**Seismic Walkdown Checklist (SWC)**

Equipment ID No: 1-1501-A7-004-000 Equip. Class<sup>1</sup> 10 - Air Handlers

Equipment Description CTB Cooling Unit & Motor

Location: Bldg. CTB Floor El. 220'±0" Room, Area 1401 Near Column #16

Equipment ID No. 1-LT-0459R Equip. Class<sup>1</sup> 18 - Instrument Racks

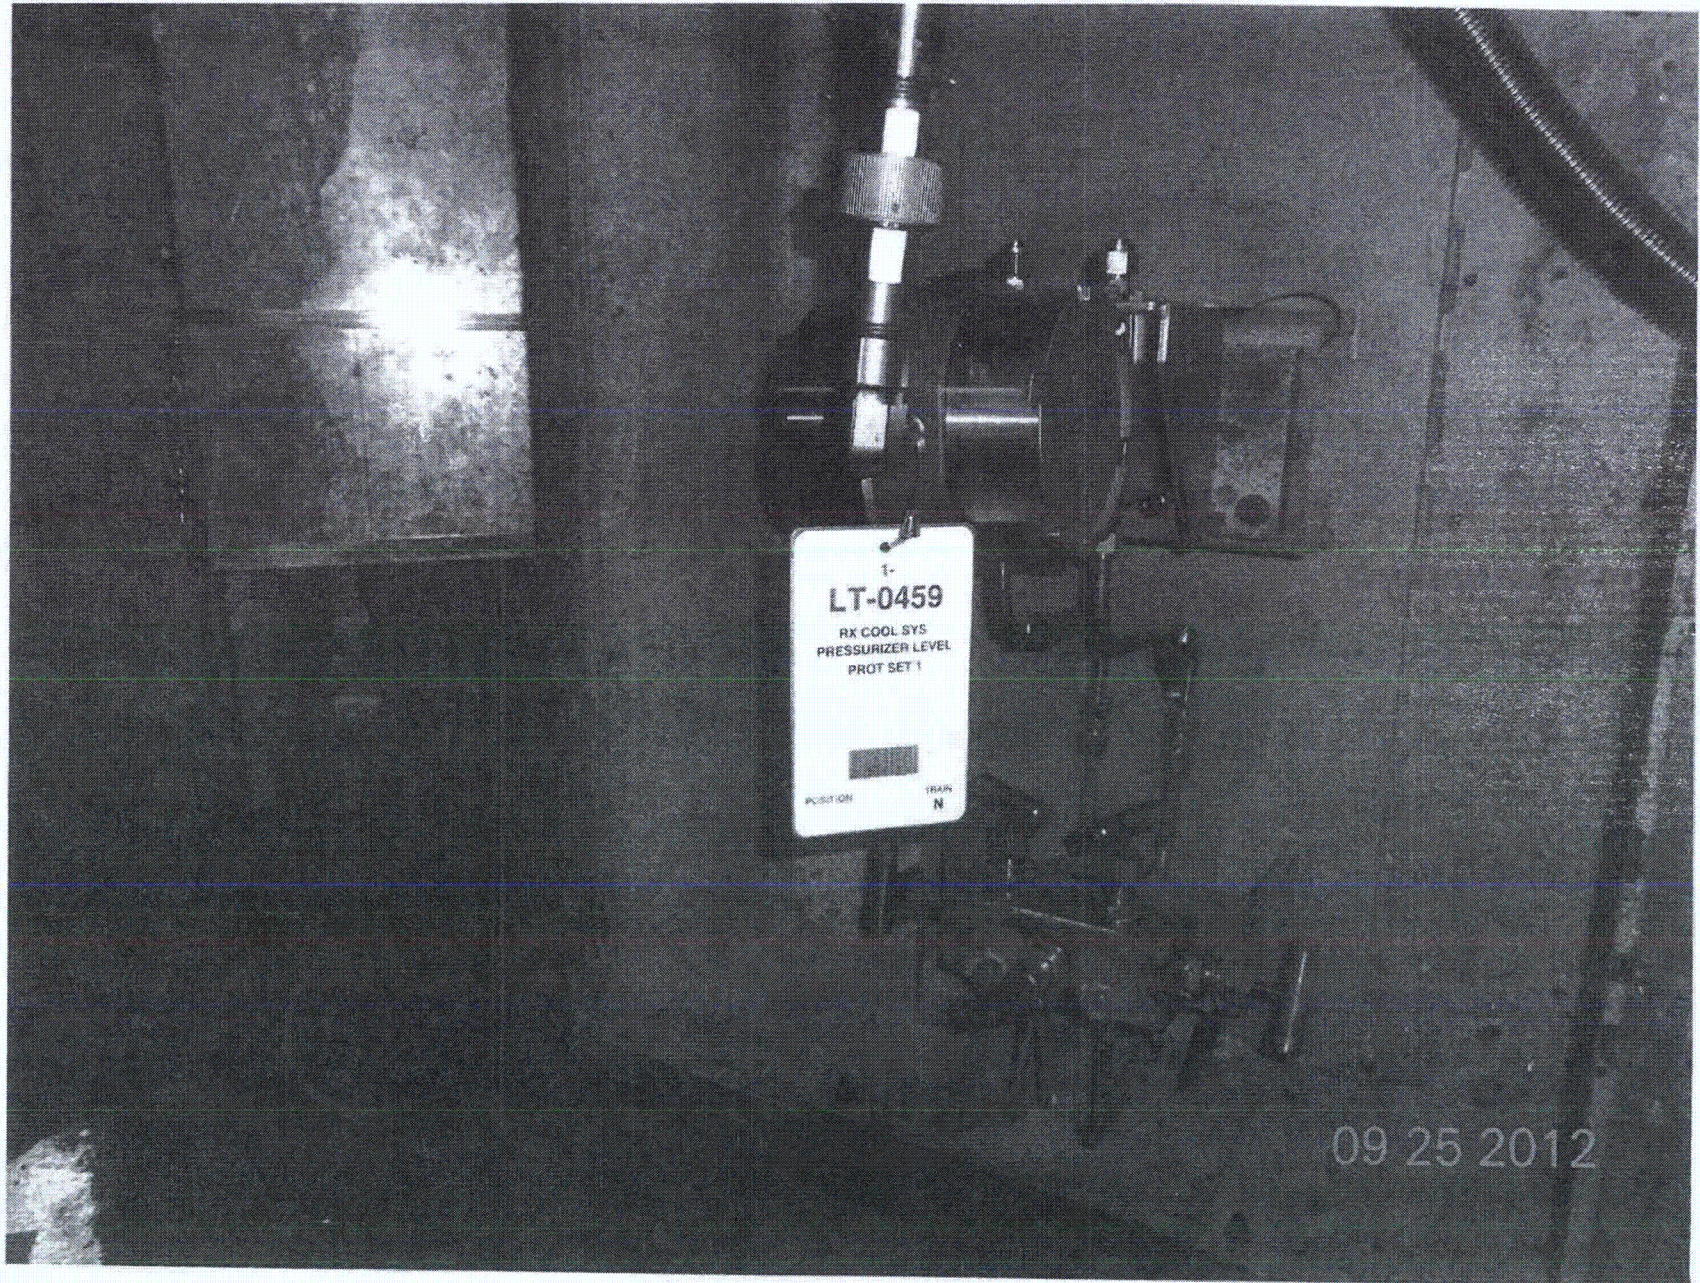
2. Is the anchorage free of bent, broken, missing or loose hardware?  Y  N  U  N/A  
*Welded to Base plate*

*Cover of box was removed at time of inspection.*

Equipment ID No. 1-1511-E7-002-000 Equip. Class<sup>1</sup> 10 - Air Handlers

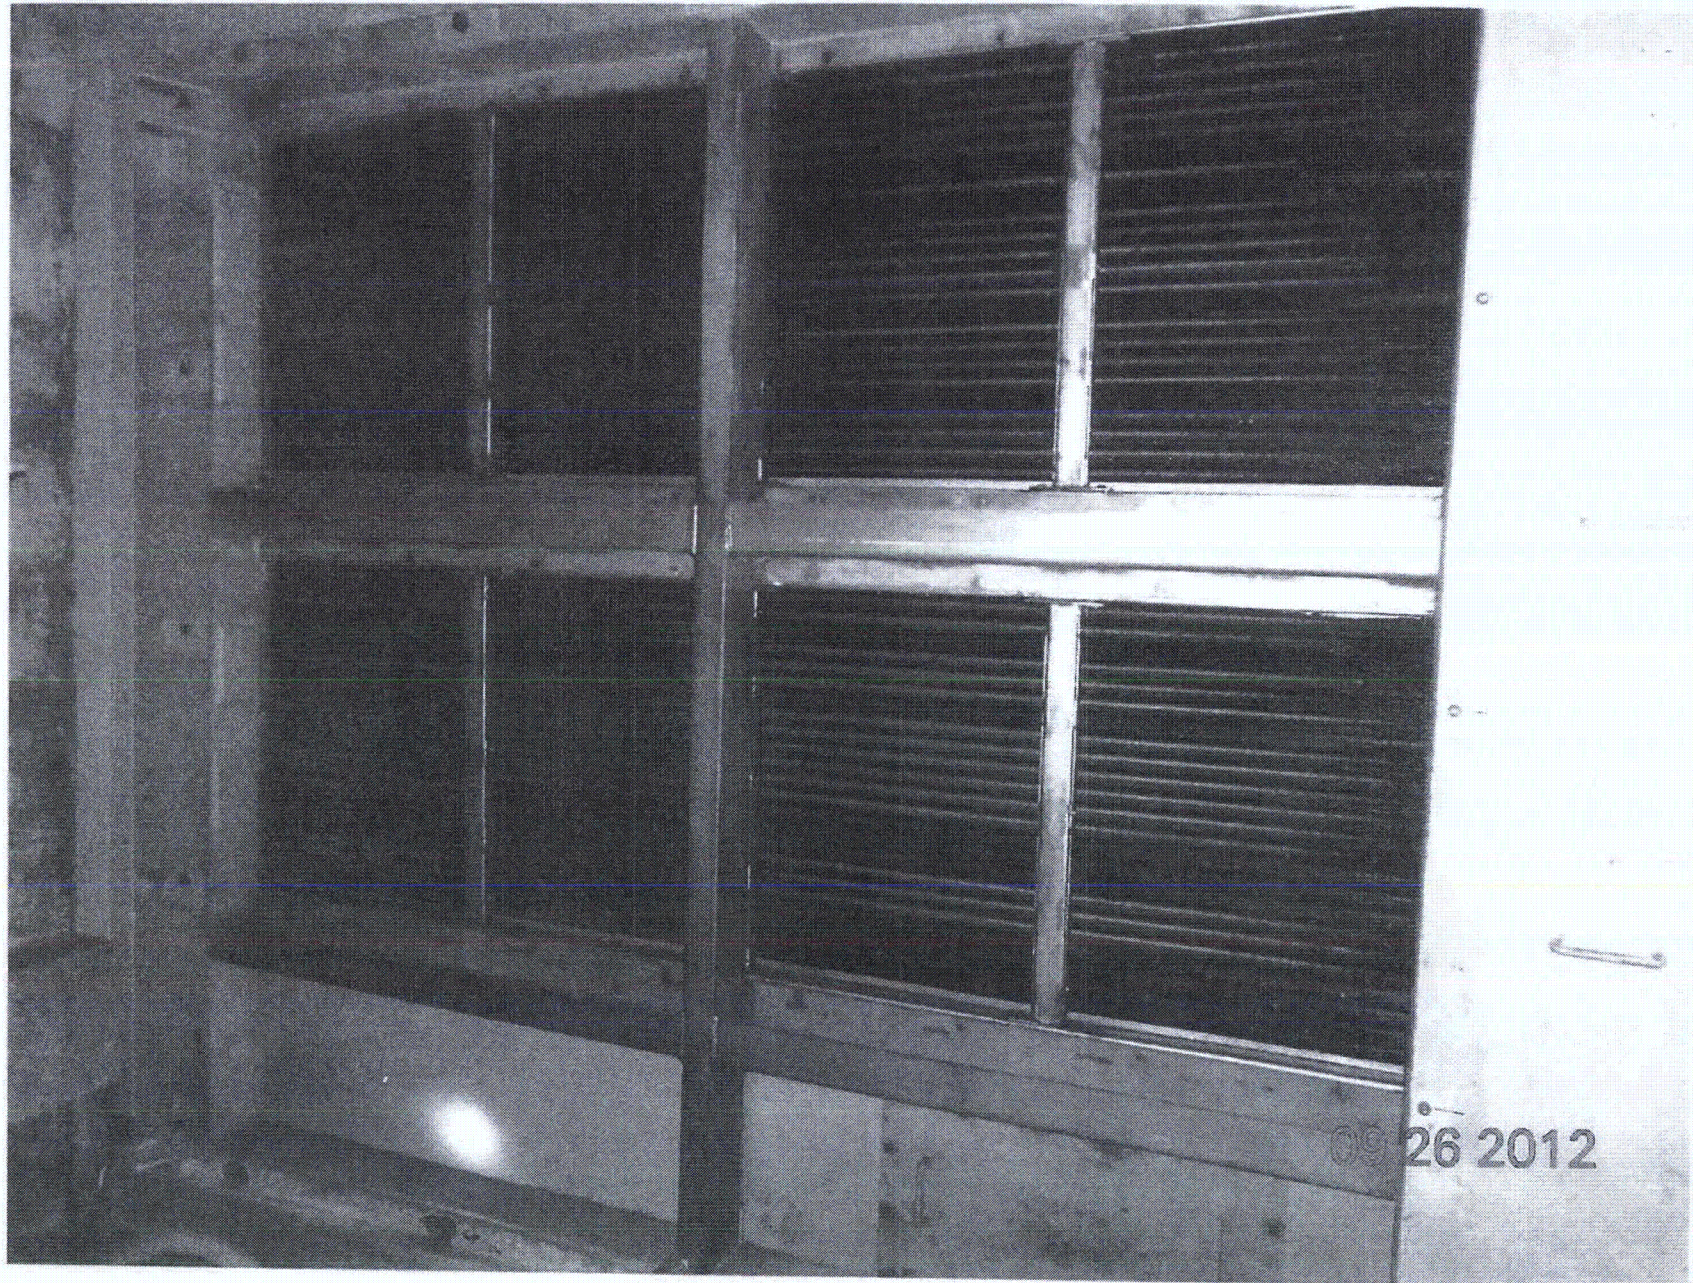
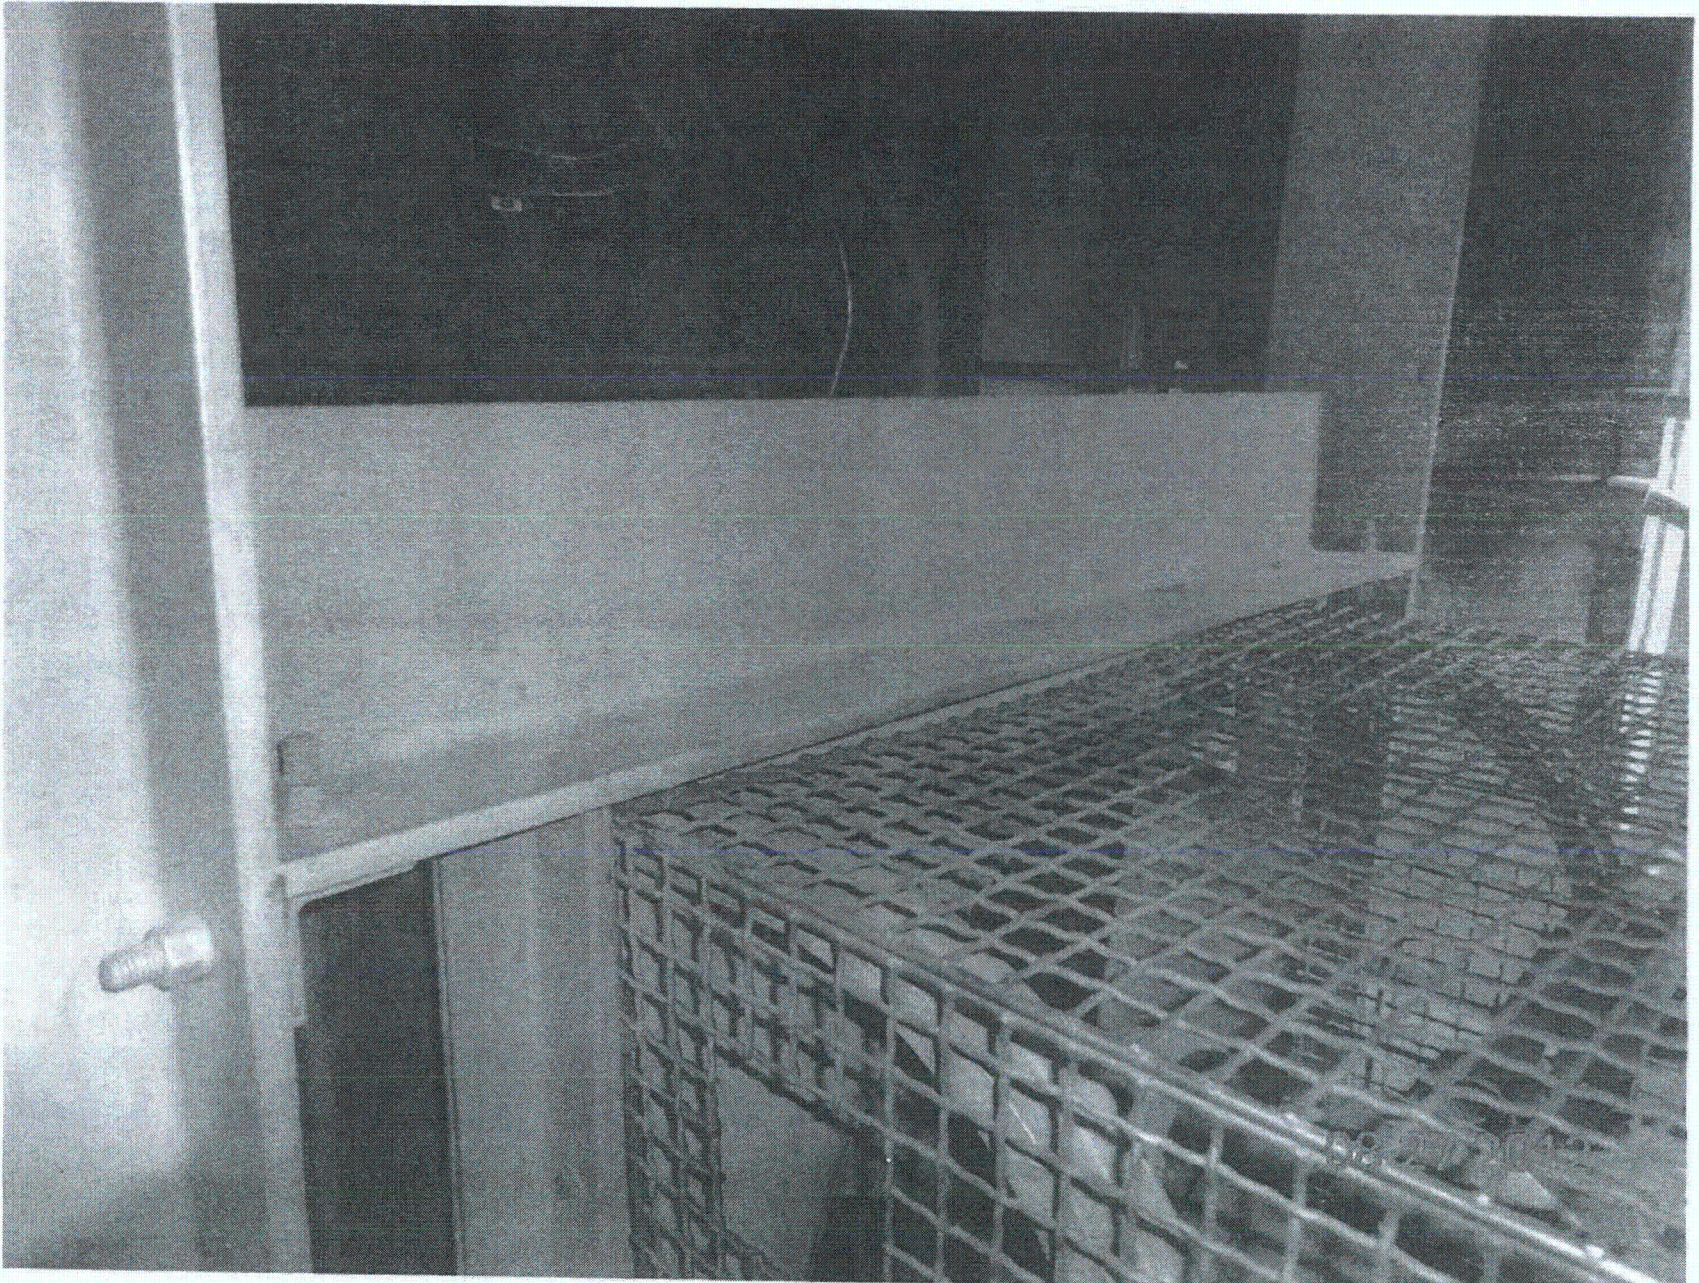
*Only mild surface oxidation was found on some anchor bolts. Therefore, the corrosion was judged to be acceptable.*

*Room is difficult to access - requires opening a heavy hatch cover at the top of a ladder.*
